ORINATION FORM

Proposed Revisions to a Standard Plans Index

Index Number: 649-020

Index Title: STEEL CCTV POLE

LAST REVISION	DESCRIPTION:		FY 2023-24 STANDARD PLANS	STEEL CCTV POLE	INDEX	SHEET
11/01/22	11/01/23				649-020	1 of 6

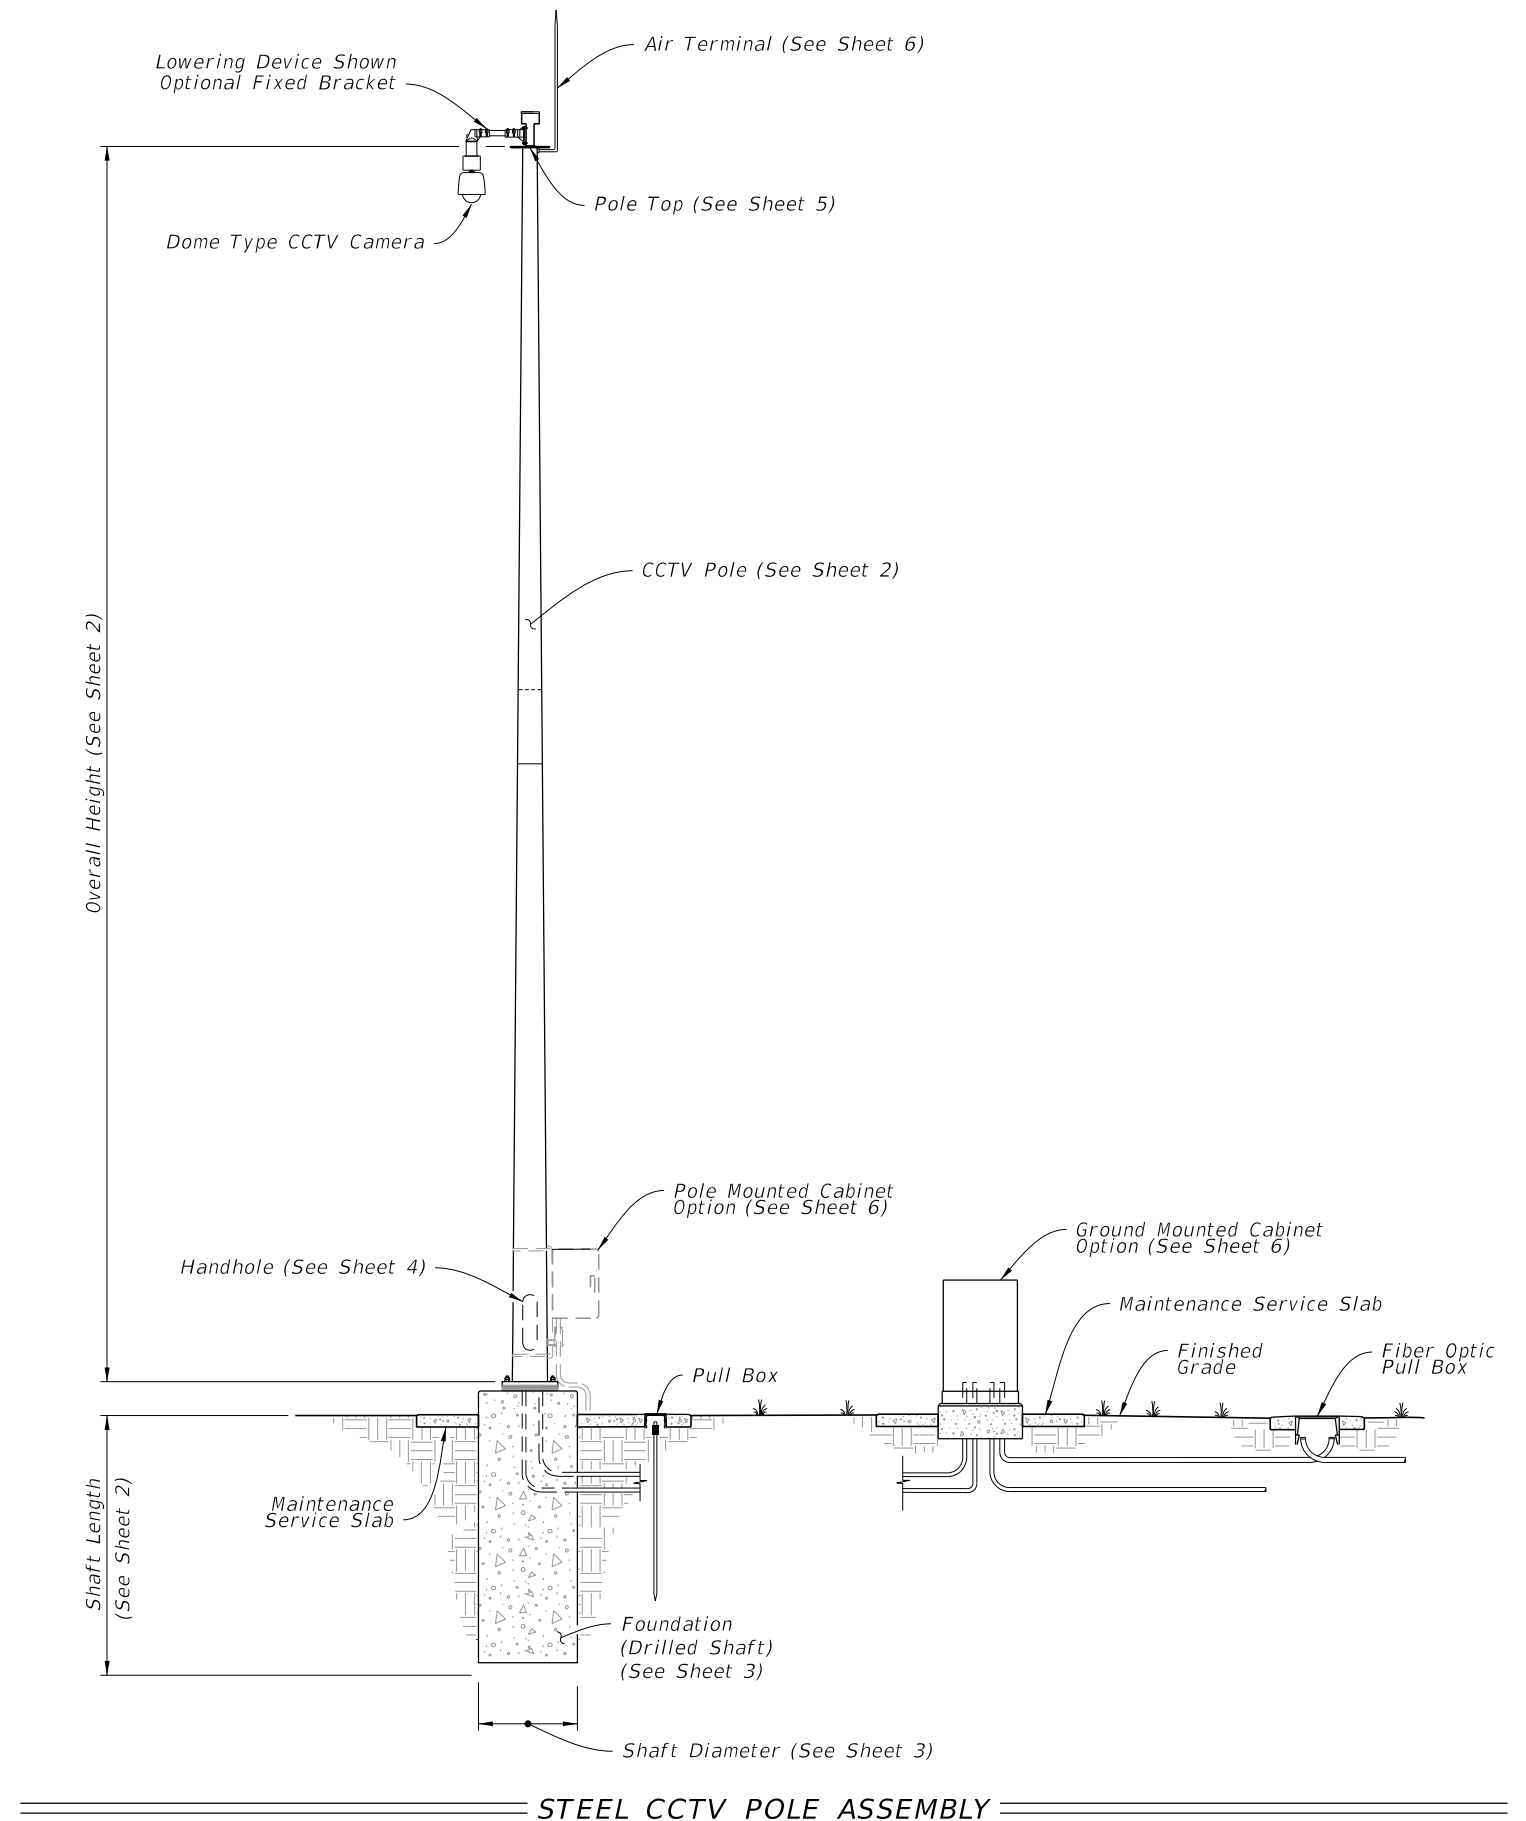
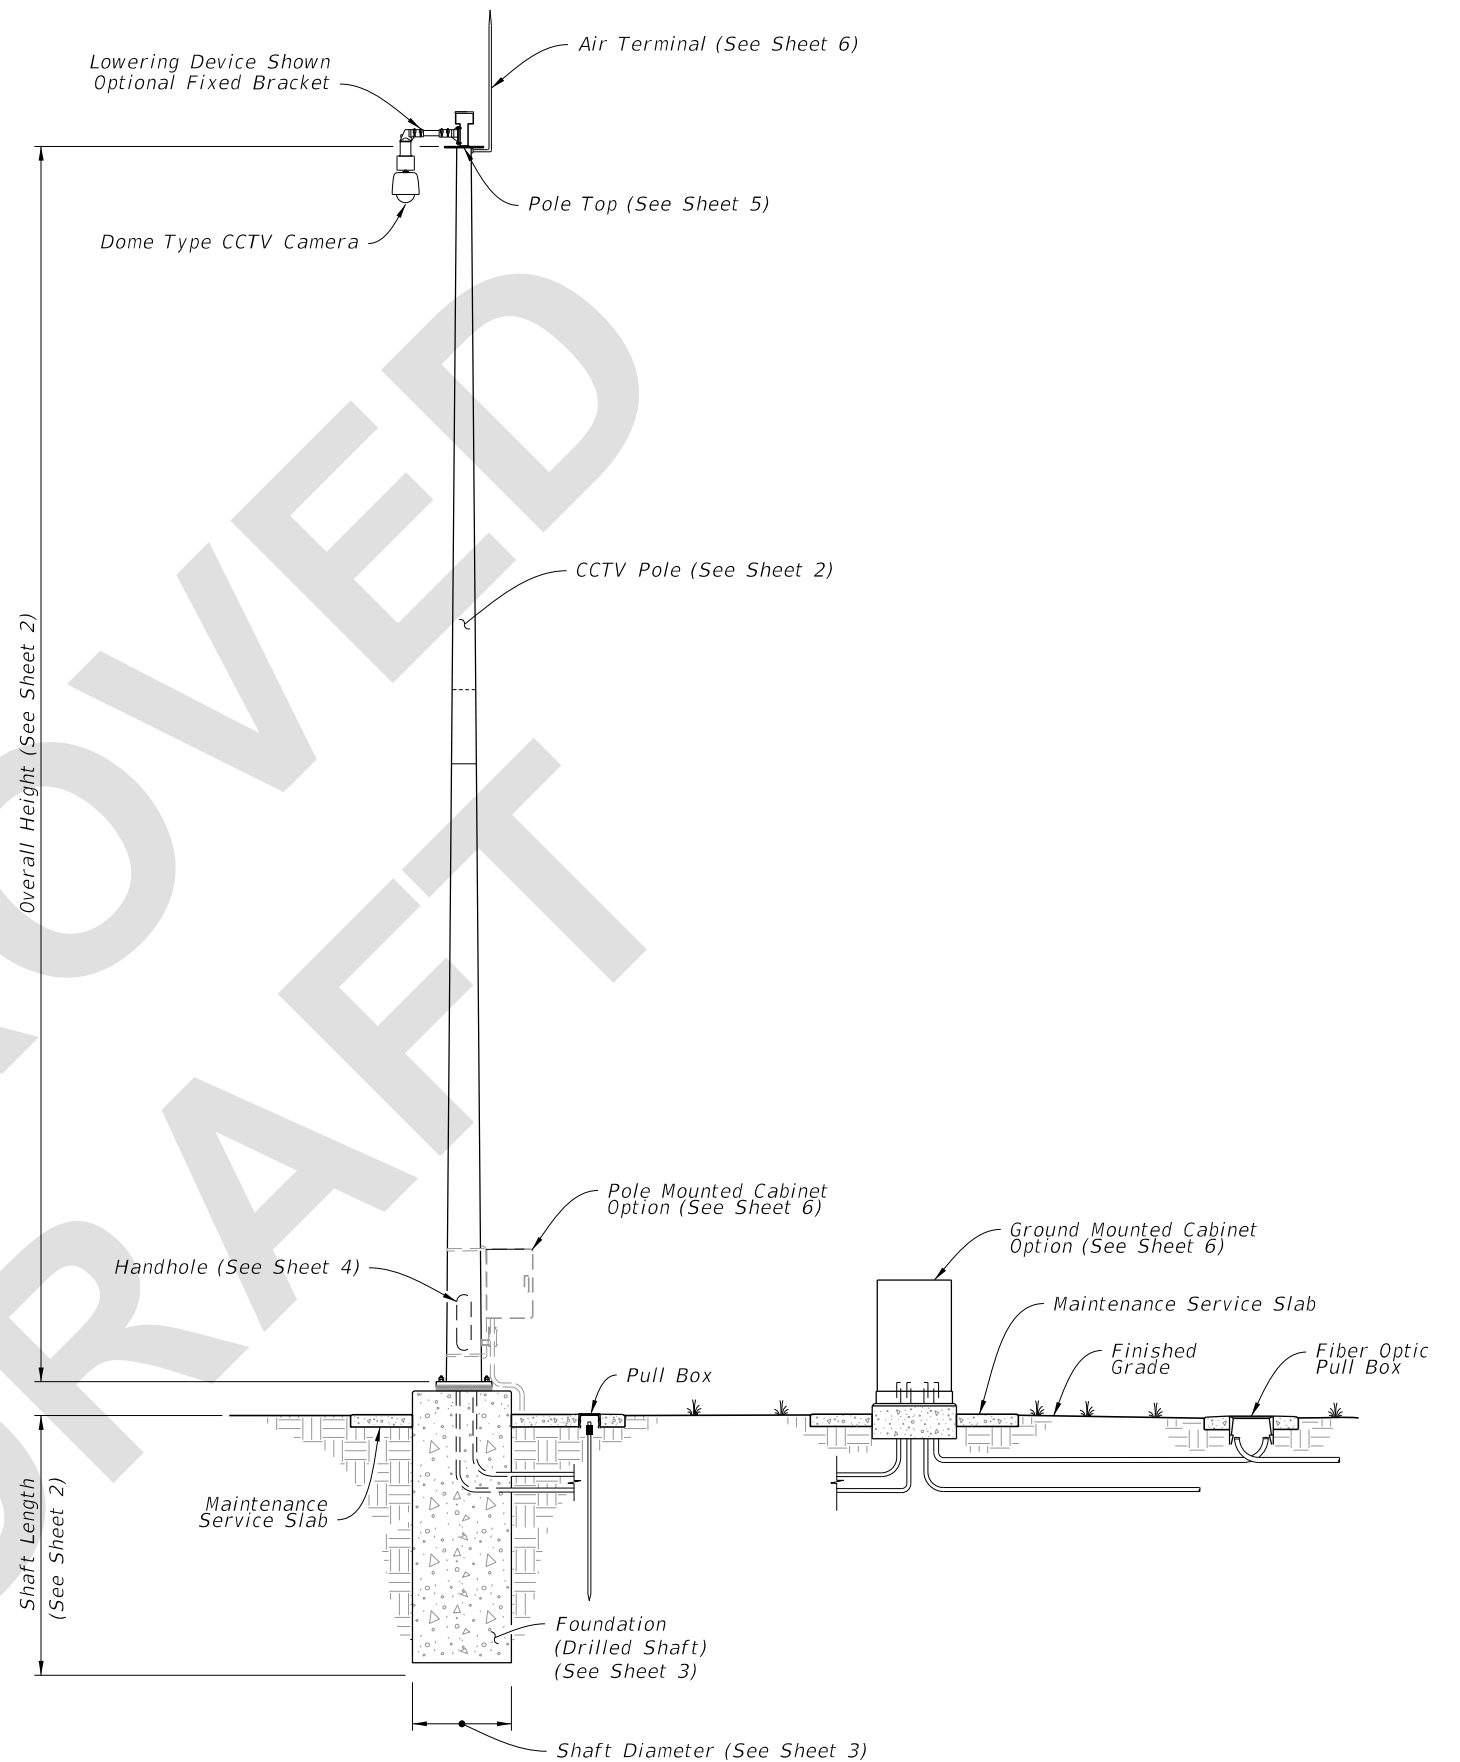
Sheet 1: Changed phrase from "full-penetration groove" to "complete joint penetration.

Sheet 1: Changing non-standard language to standard language consistent with AWS.

1. Use a ~~full-penetration groove weld~~ within 6 inches of the circumferential tube-to-plate connection and
 2. Use ~~full-penetration groove welds~~ on the female end section of telescopic (i.e., slip type) field splices for a minimum length of one and one-half times the inside diameter of the female section plus 6 inches.

complete joint penetration

1. Use a complete joint penetration weld within 6 inches of the circumferential tube-to-plate connection and
 2. Use complete joint penetration welds on the female end section of telescopic (i.e., slip type) field splices for a minimum length of one and one-half times the inside diameter of the female section plus 6 inches.

LAST REVISION 11/01/23	REVISION	DESCRIPTION:		FY 2024-25 STANDARD PLANS	STEEL CCTV POLE	INDEX 649-020	SHEET 4 of 6
---------------------------	----------	--------------	--	------------------------------	-----------------	------------------	-----------------

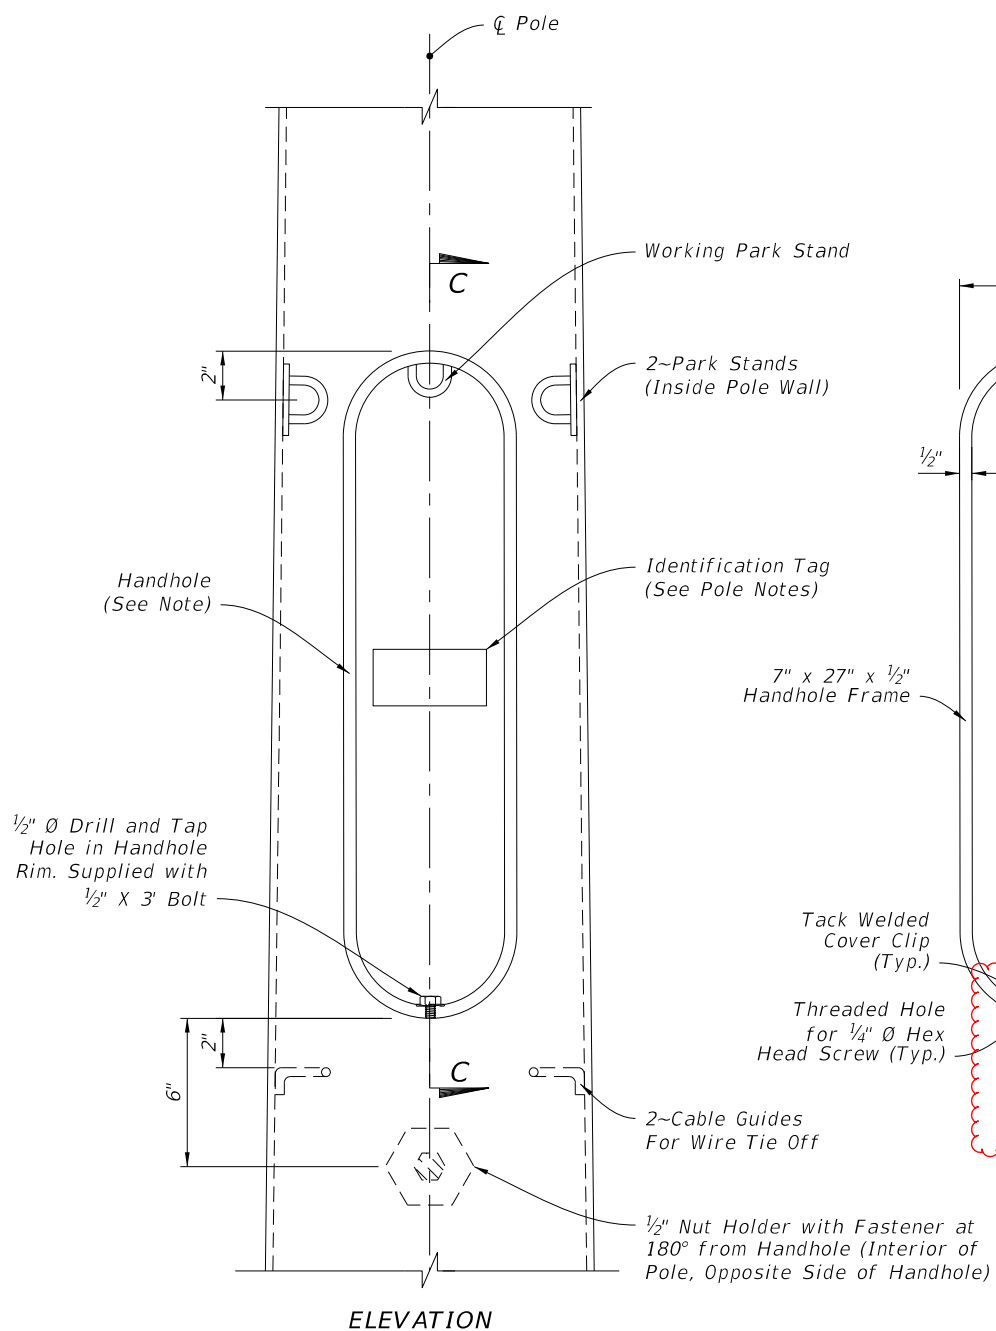
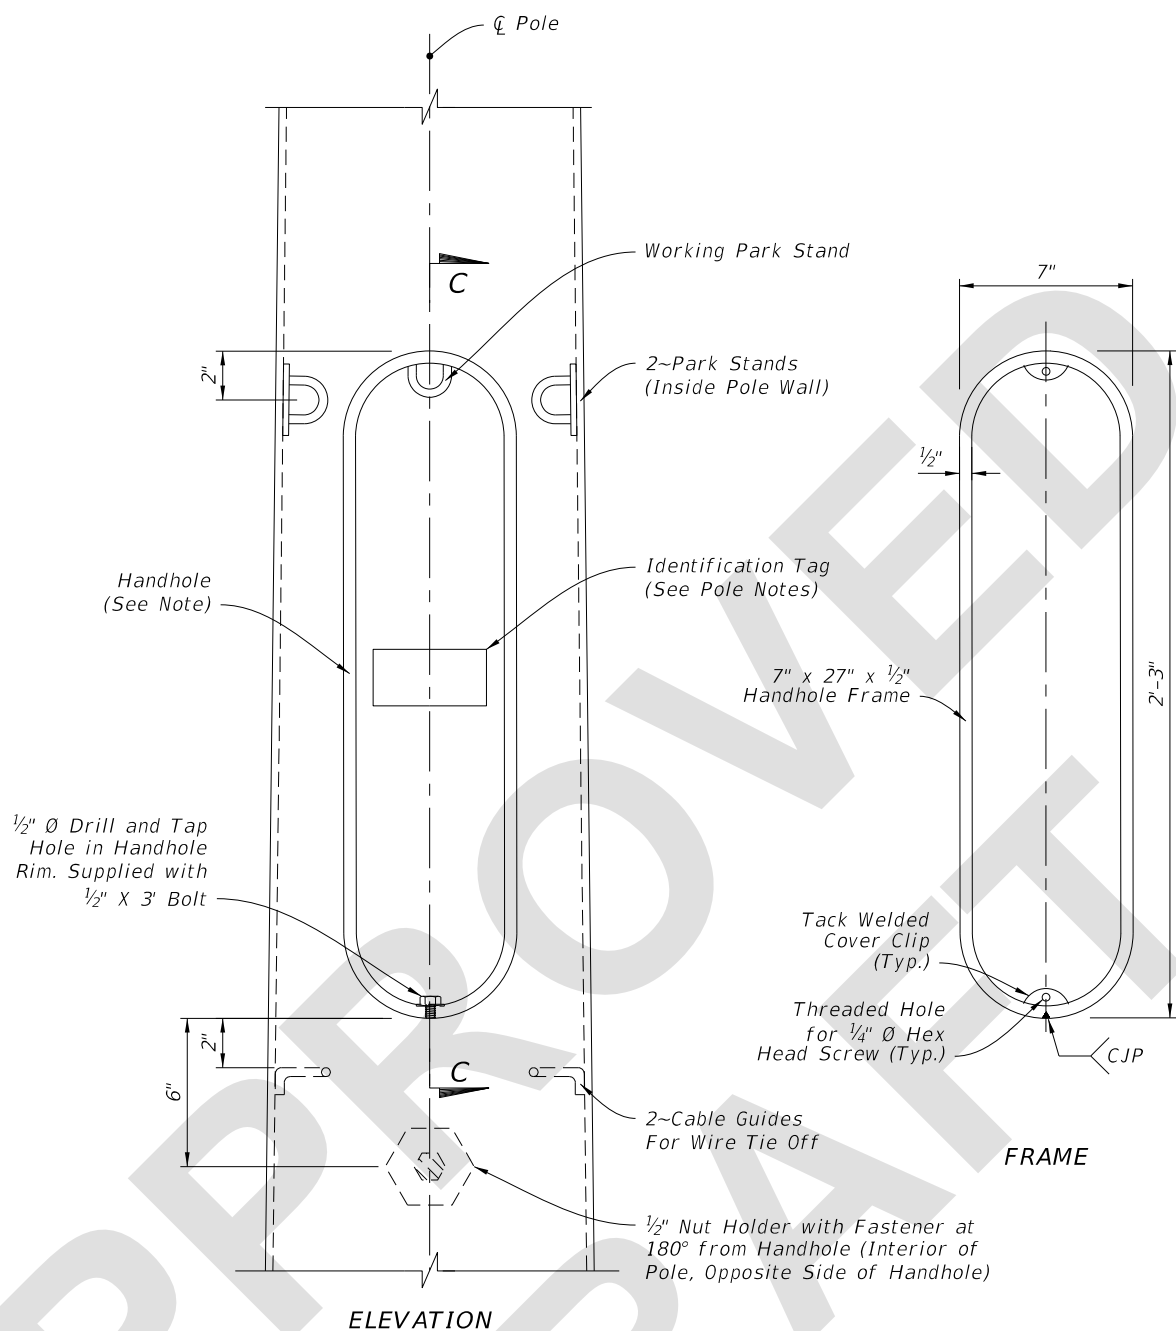
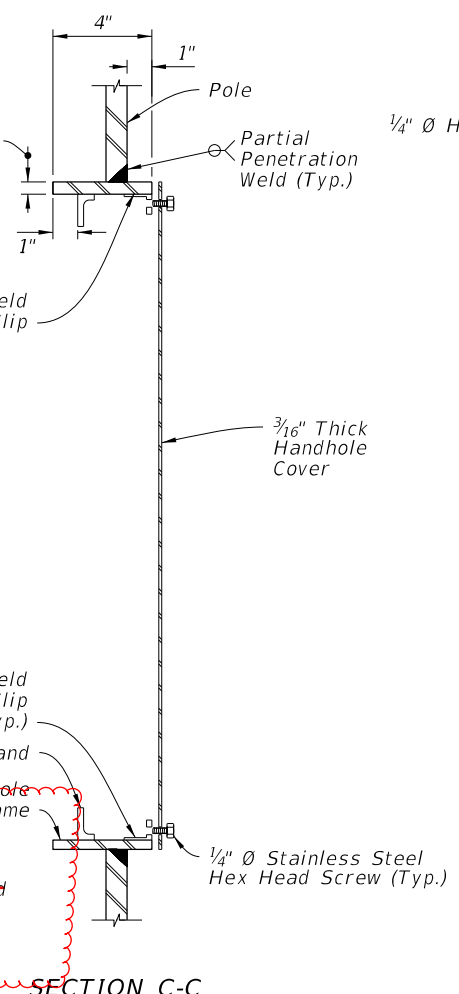
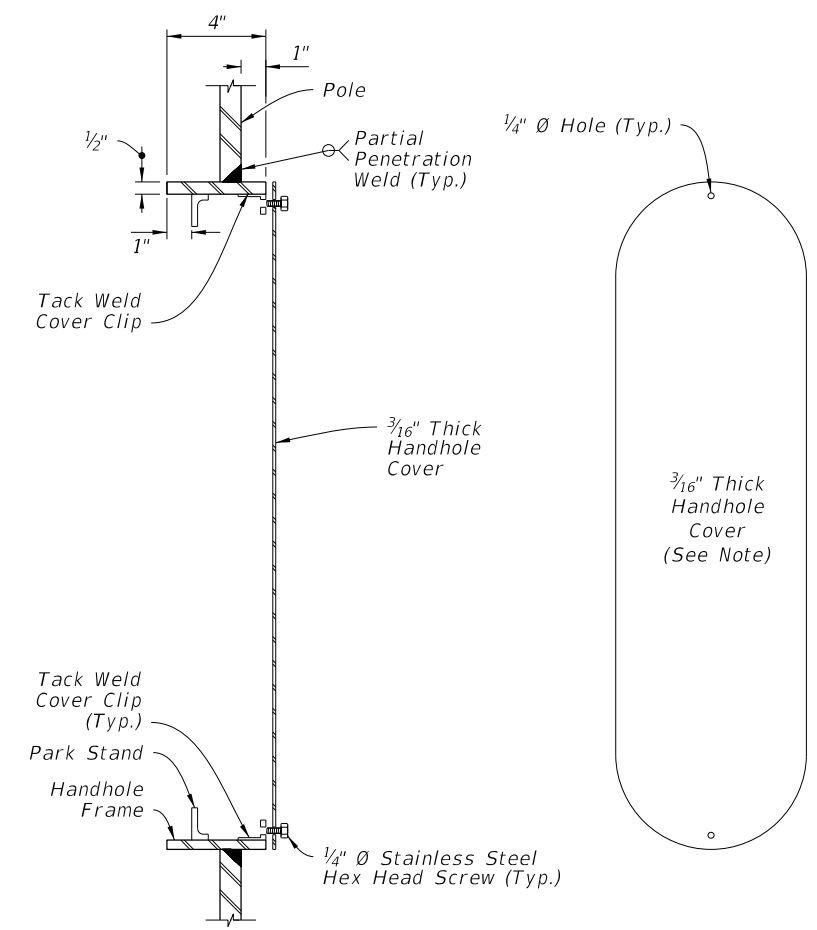
Sheet 4: Changed weld detail to say "CJP."

Sheet 4: Changing non-standard language to standard language consistent with AWS.
